E8362CH85-01A

S E R V I C E N O T E

E8362CH85 PNA Microwave Network Analyzers

A new touchscreen display inverter shield is available to improve PNA noise floor performance.

Figure 3

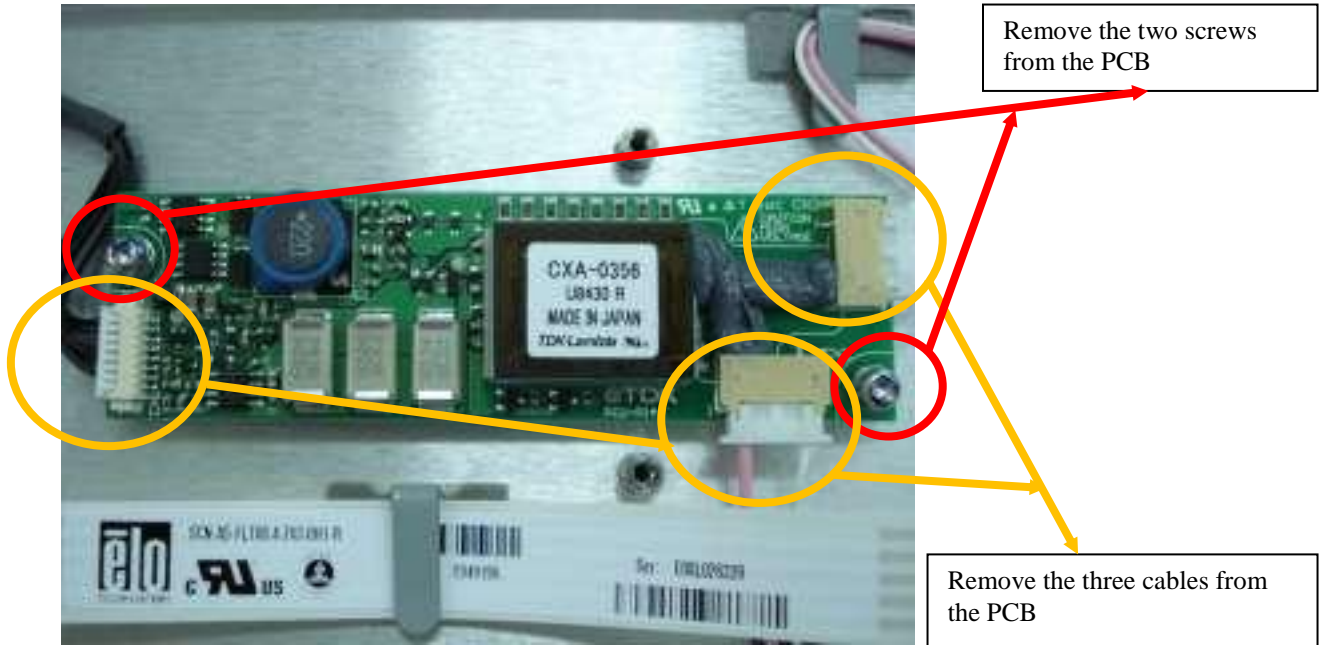
10. Remove the two screws from the PCB shown in Figure 3, using a T-10 wrench.
Disconnect the three cables connected to the PCB.
